ADDENDUM No. 2

Re: WCU Early Joyner Drive Infrastructure Package

JPA Project #: 20WCU777 SCO Project #: 22-24697-01B

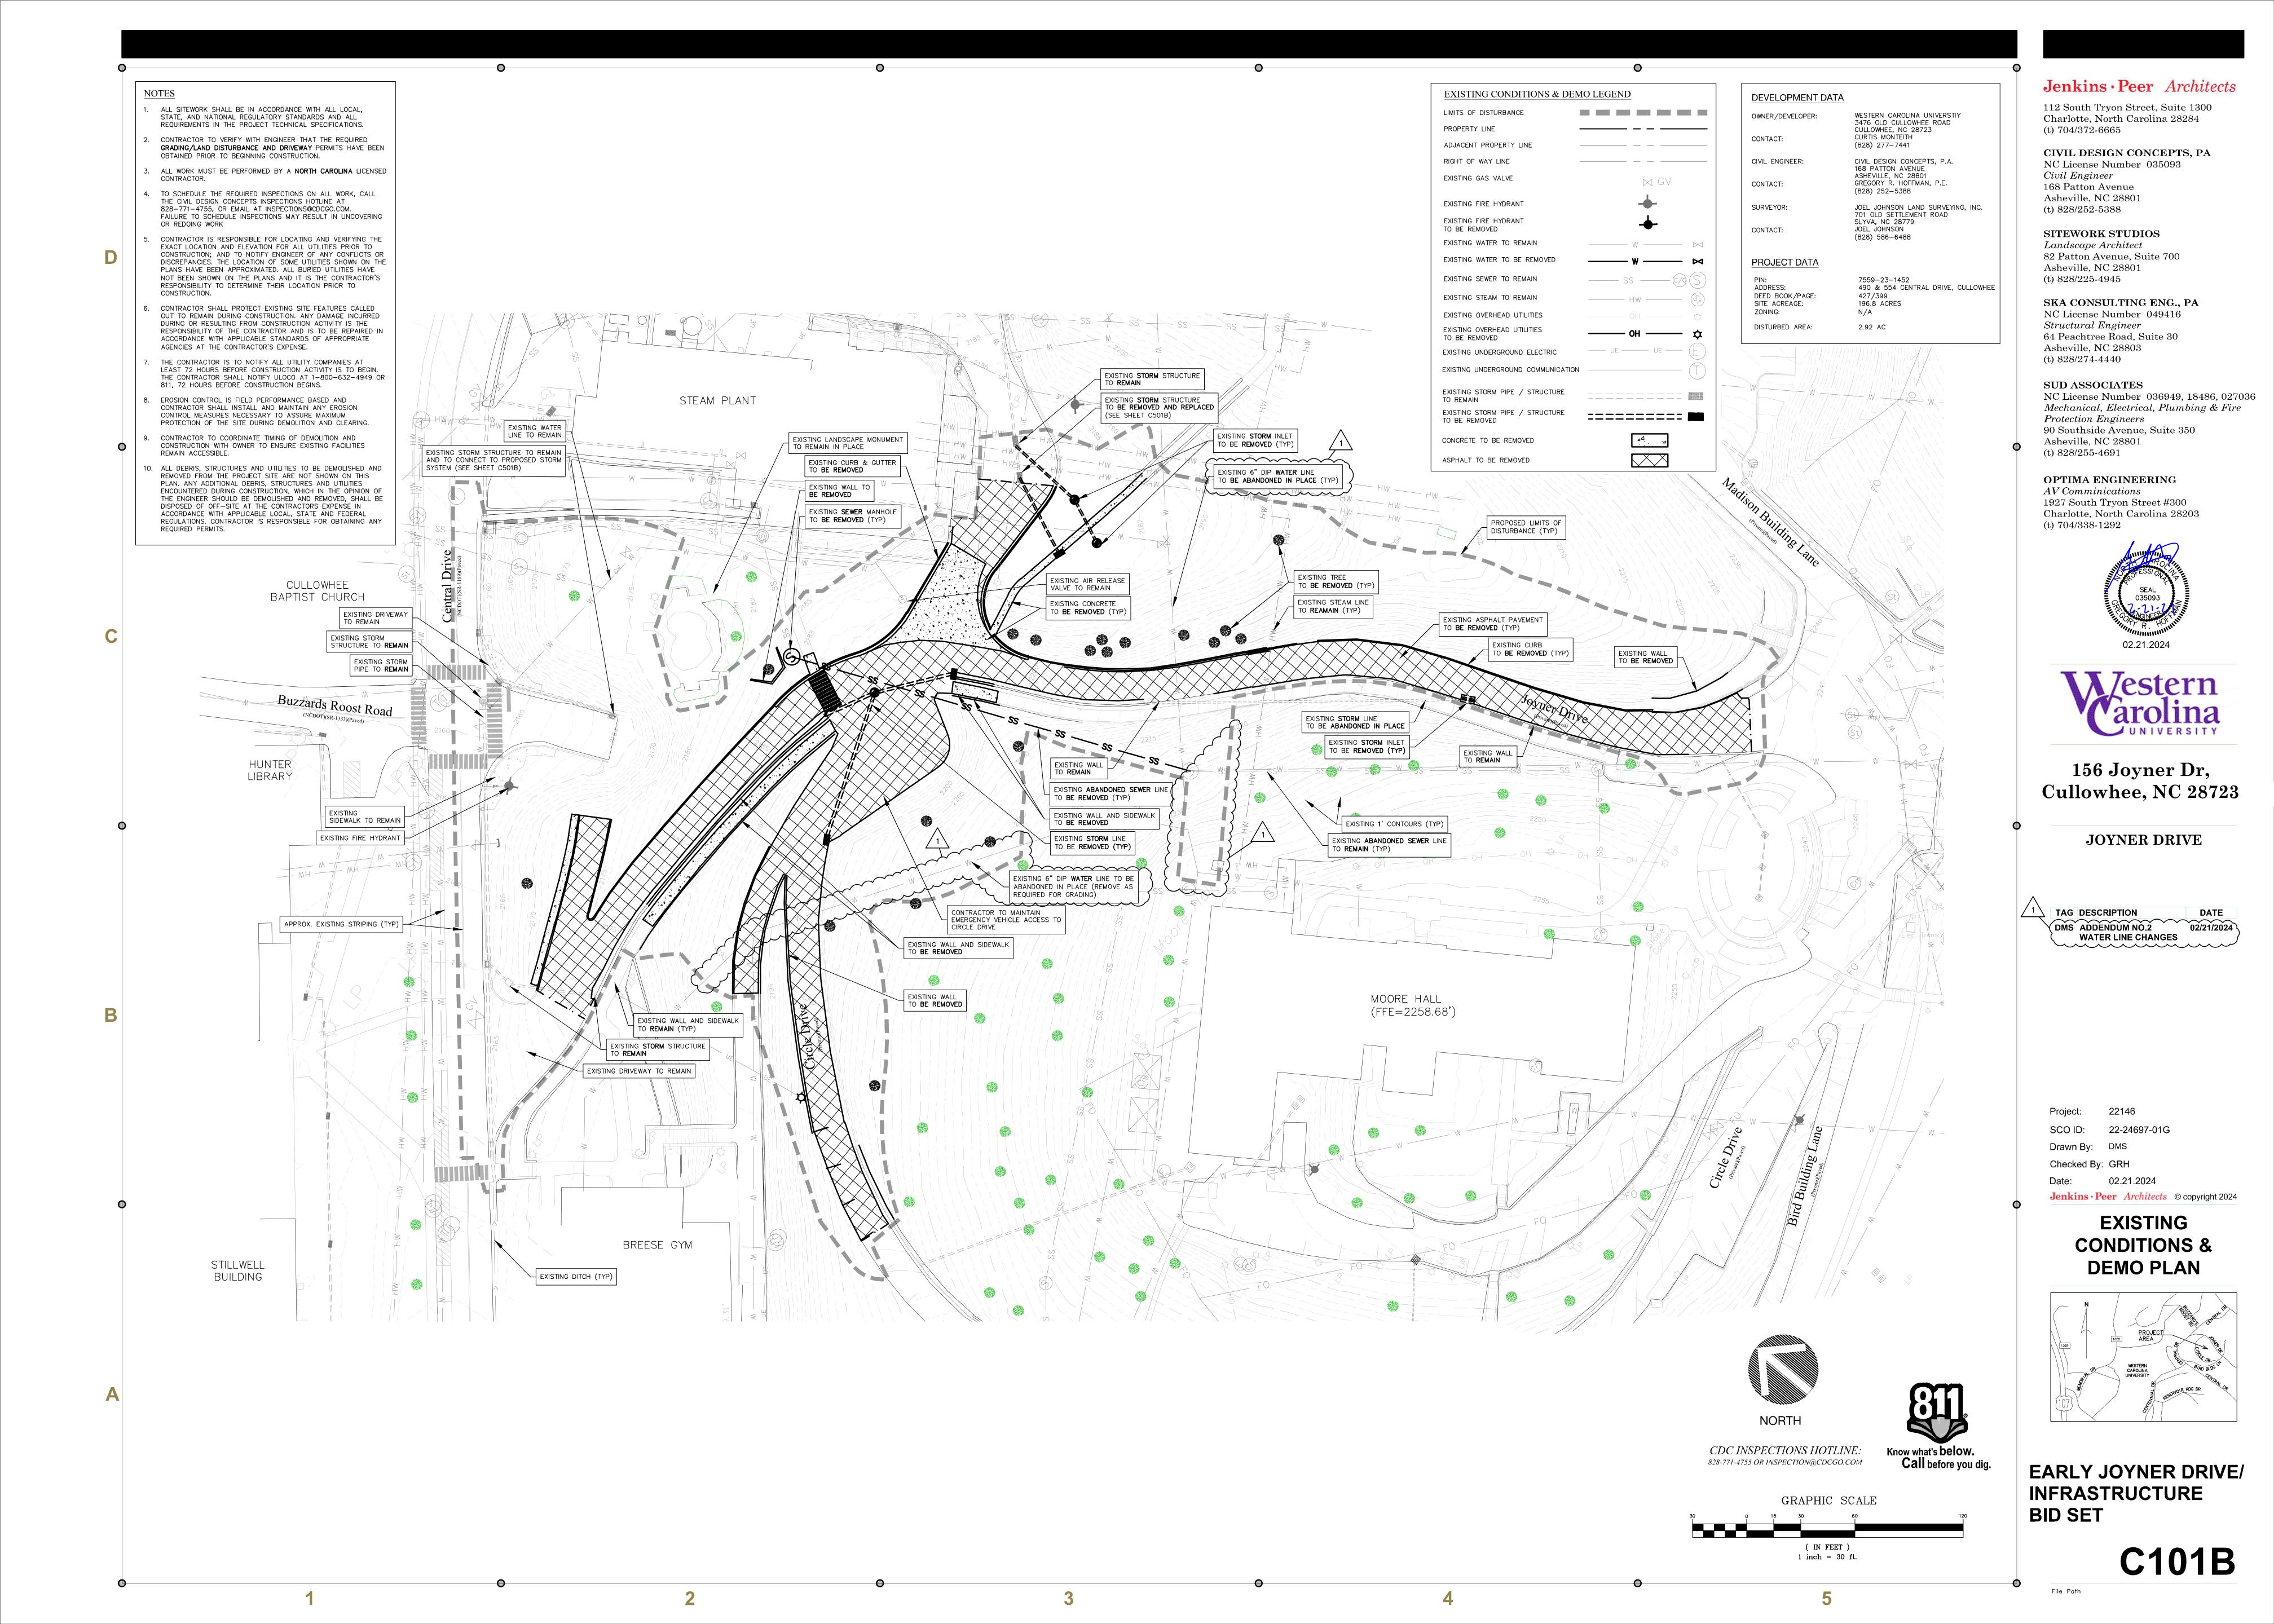
1) Sheet C201B shows the fence behind the wall. The detail on sheet C921B shows the fence as if cored into the wall units. Which is correct?

The detail is correct.

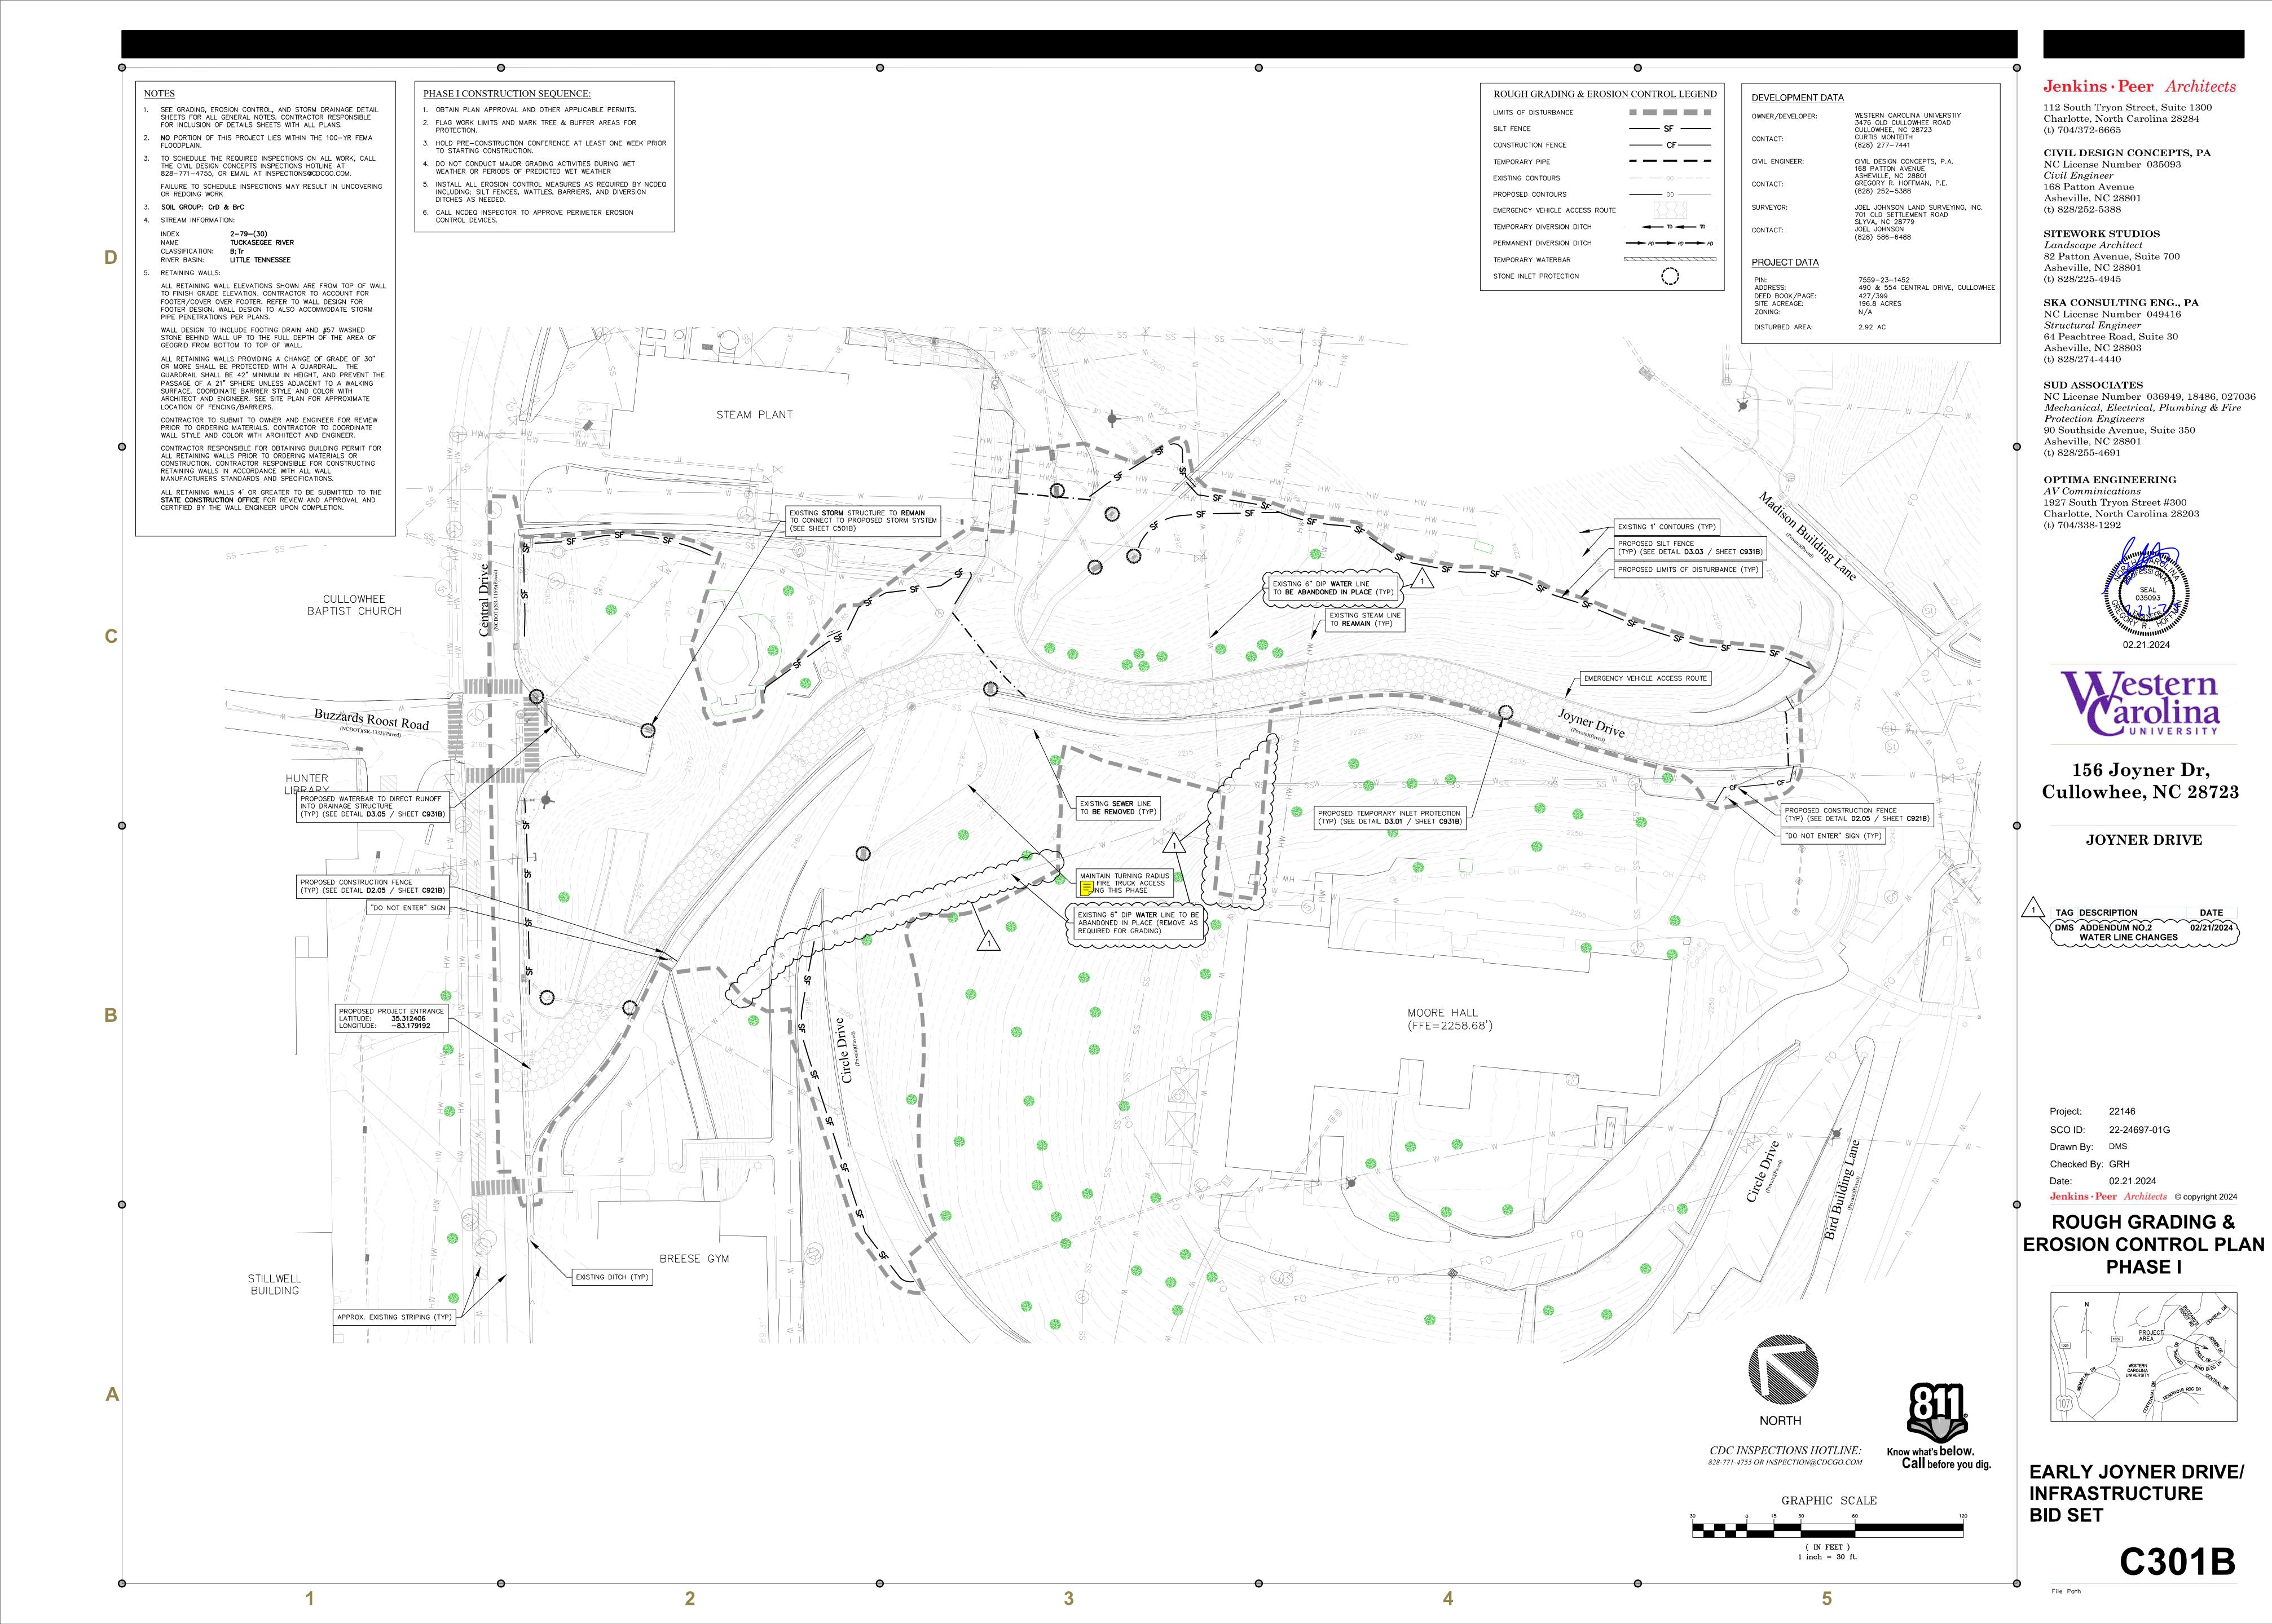
2) Sheet C921B, detail D2.05, shows chain link fence to be 6'-0" tall. Sheet C921B, detail D2.08 shows the chain link fence on top of the wall to be 4'-0". That shown in D2.08 would be typical of safety fence at the top of walls. Which detail is correct for the height of the vinyl coated chain link fence? The fence above retaining wall should be 4' in height.

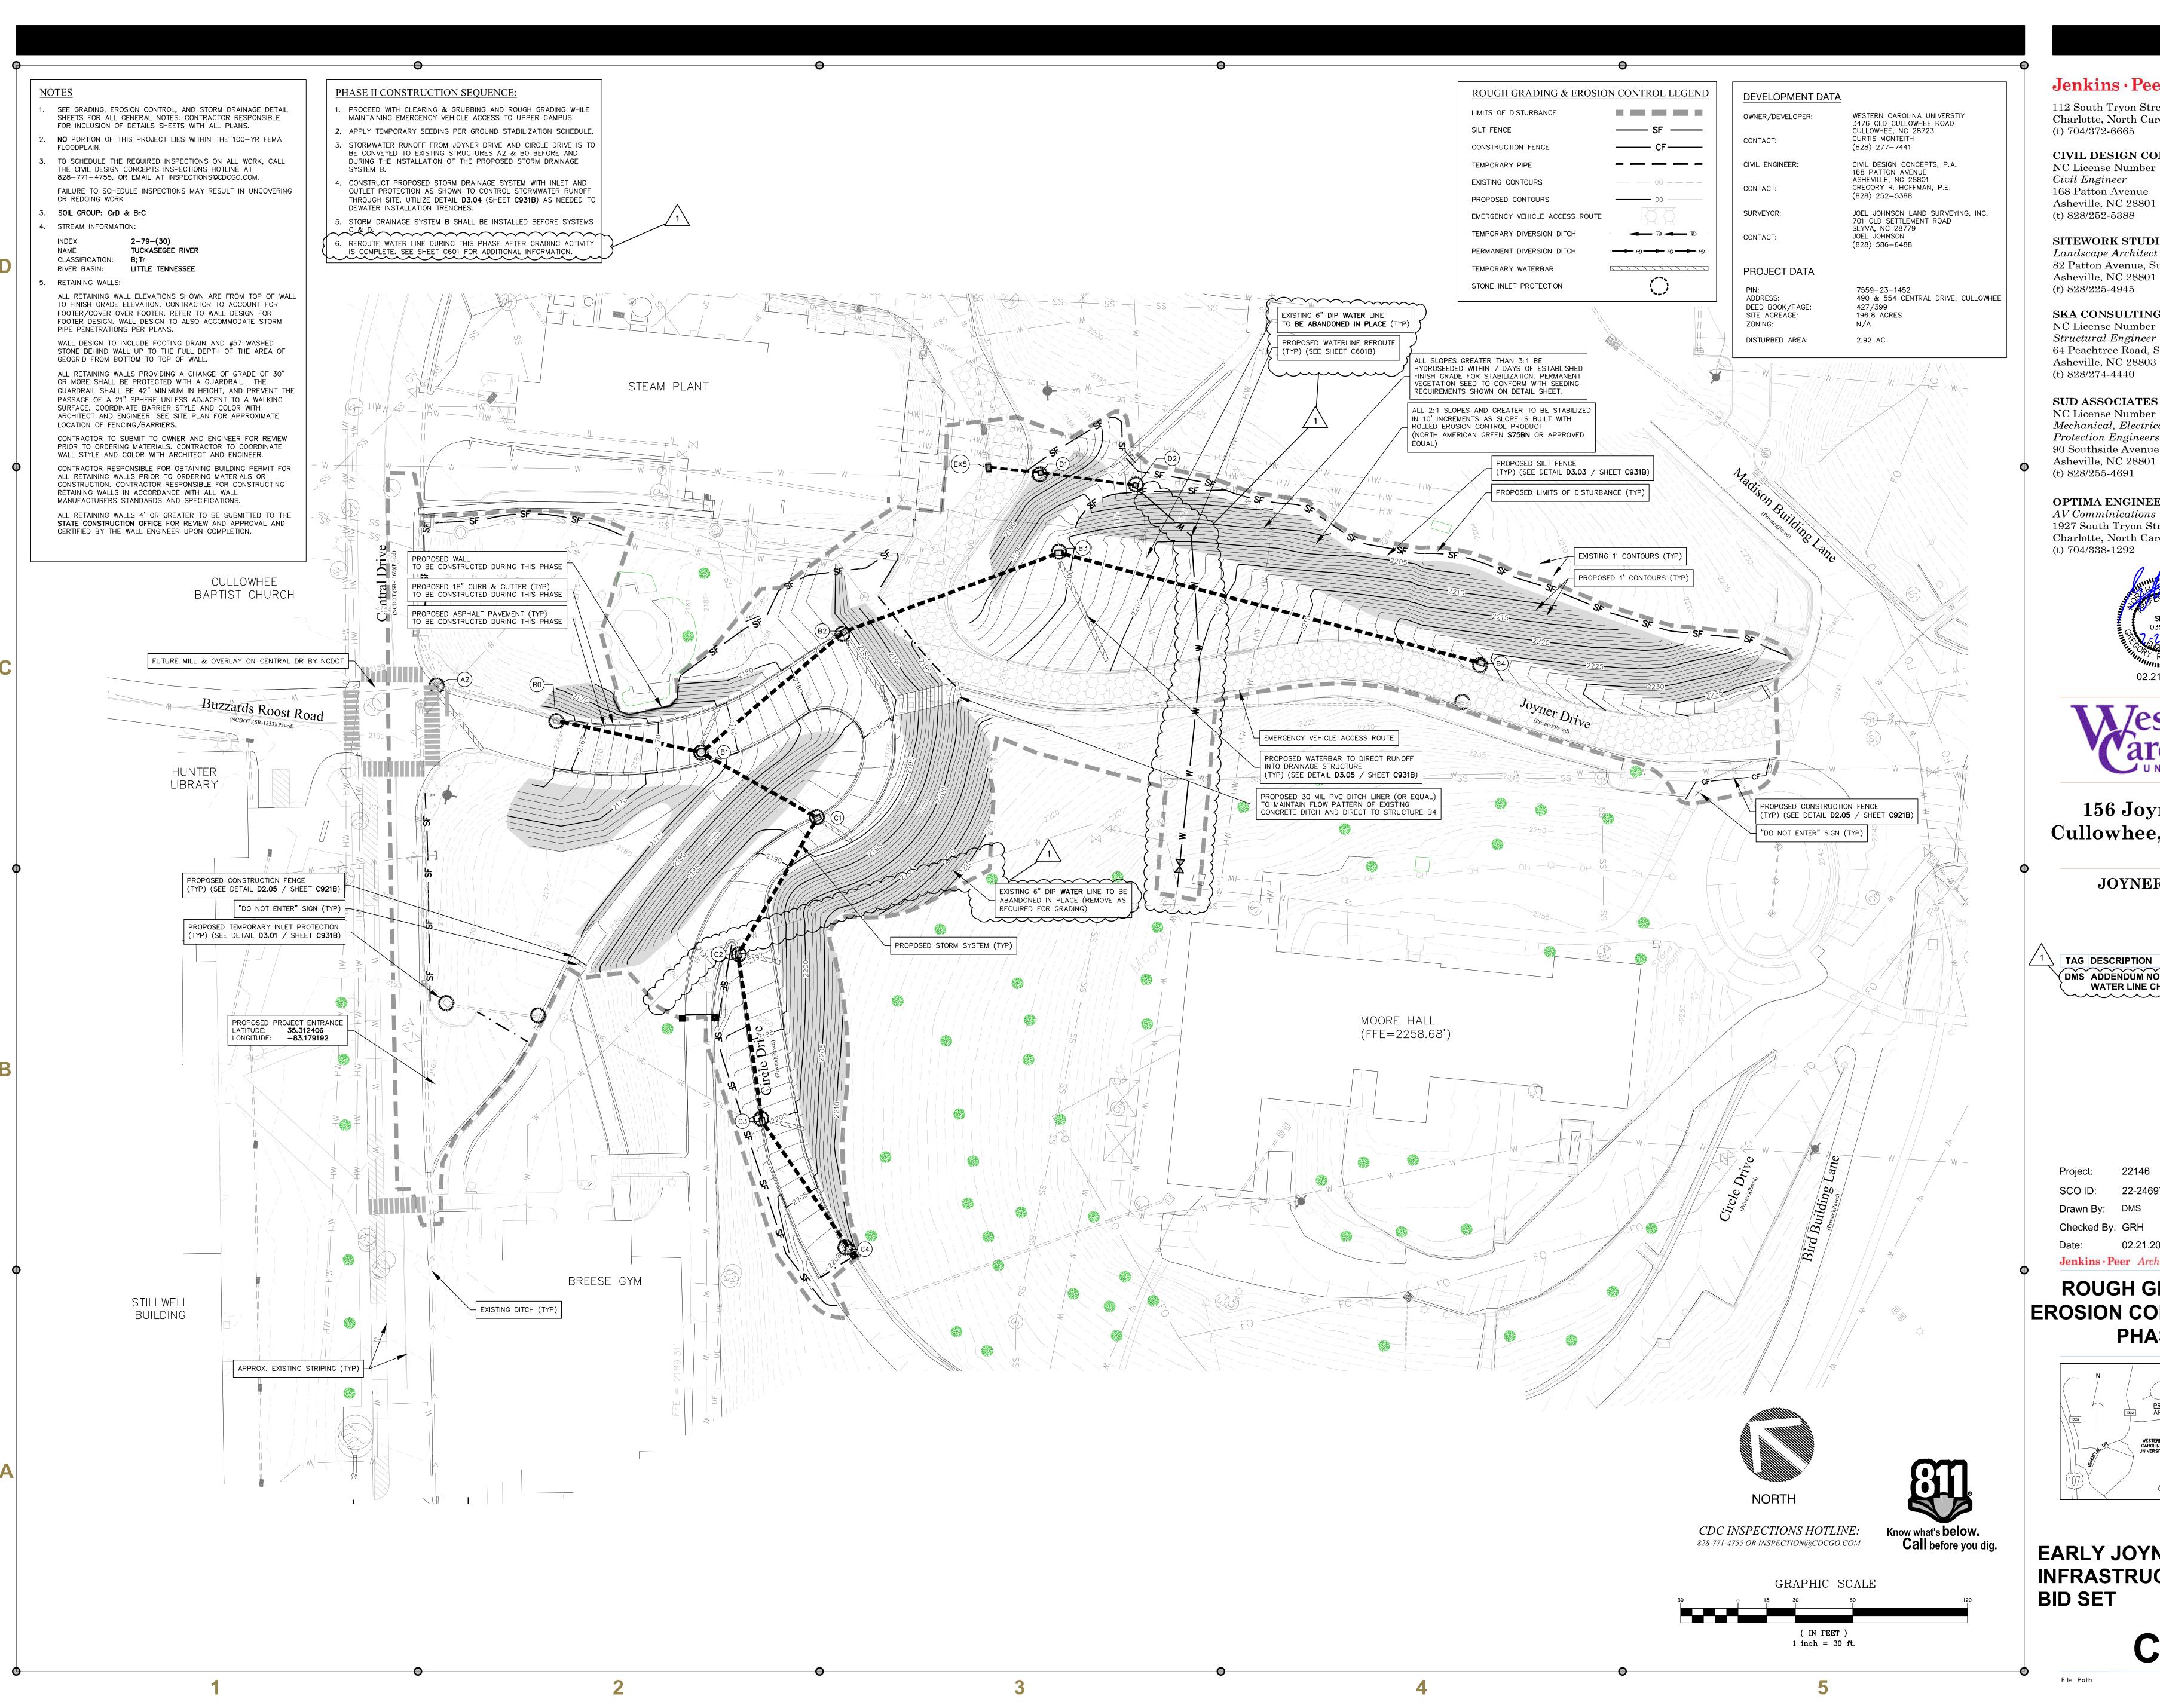
3) Sheet C921B, detail C2.08 shows segmental wall units (like keystone units). The specification is titled "Segmental Wall Units"; and the specification addresses issues of construction of segmental wall units. However, the notes on the plans and the specification states that the basis of design for wall units is: Redi-Rock (Gravity Units); Vertiblock (Gravity Units); and Recon (Gravity Units). Will the wall be constructed as segmental wall units or as gravity wall units?
The walls are delegated design. The large units, as noted in the basis of design, should be priced and designed accordingly.
